LiDAR Quality Assessment Report

UT_Southern_QL1_2018

NGTOC
 2019-03-21
 Brian Pfeiffer

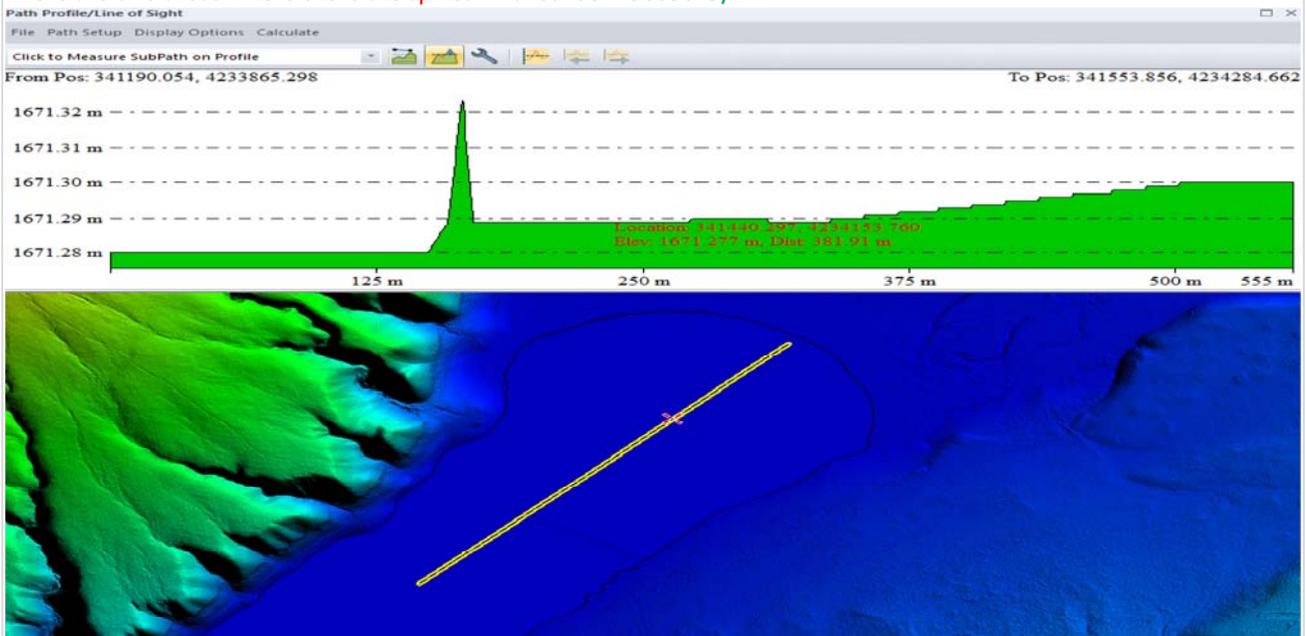
There are two areas where there are spikes in lakes. corrected 3/21

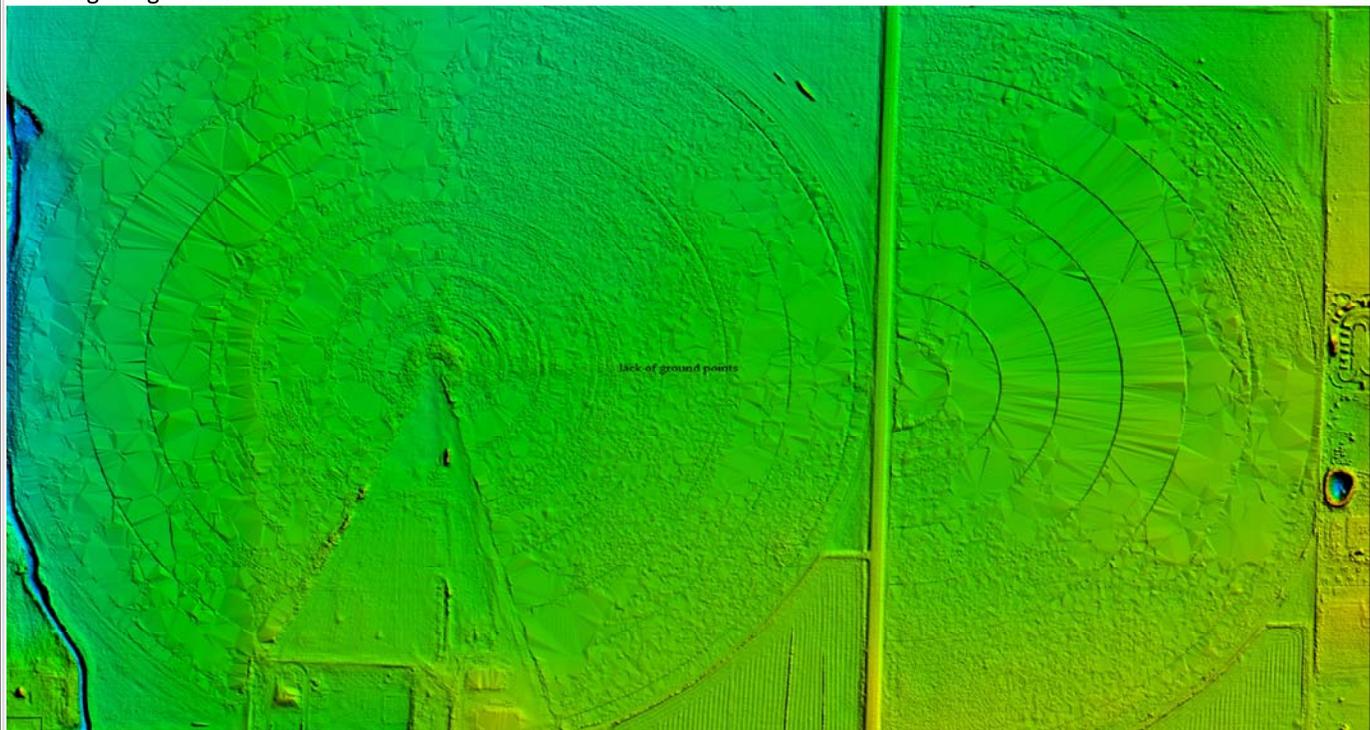
There are three bridges that should be removed from the ground class. corrected 3/21

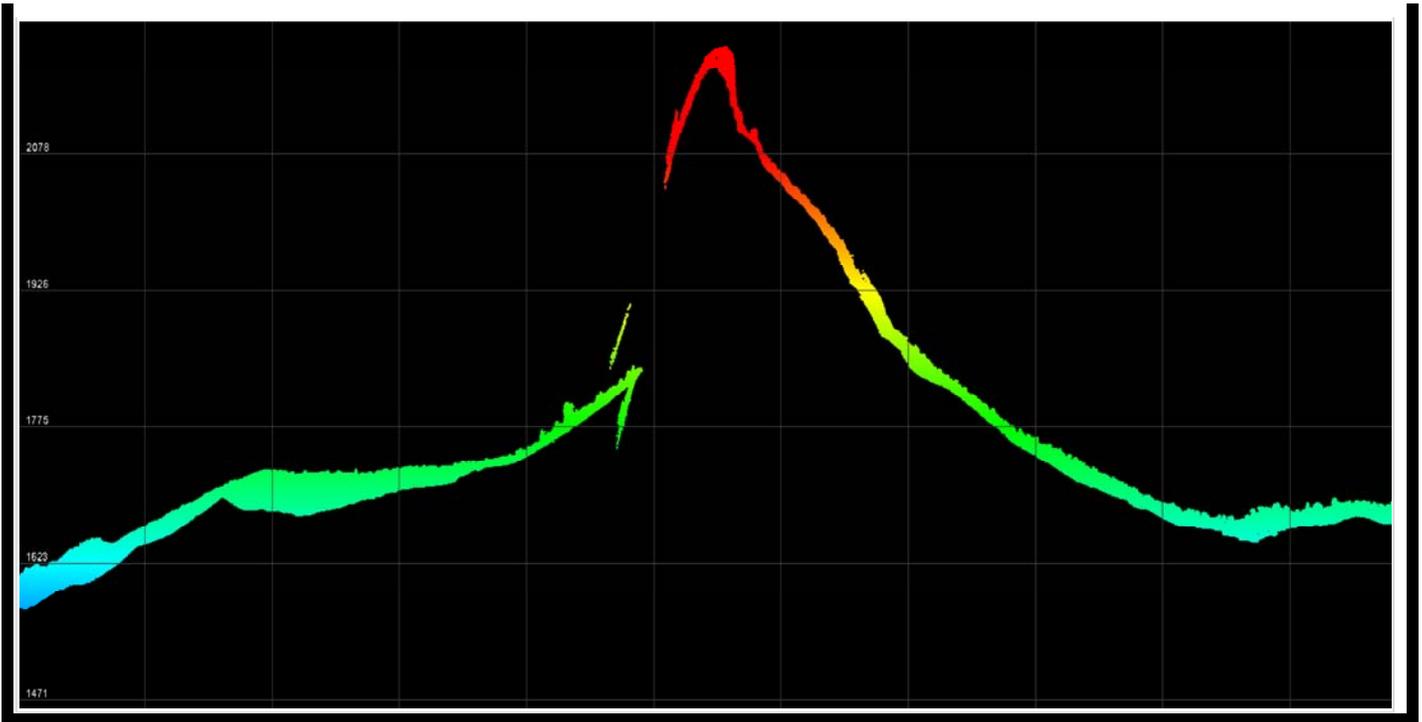
There are 16 areas where there are data voids in the ground class caused by very dense crops that prevent the laser from reaching the ground.

There is one data void caused by a sheer cliff.
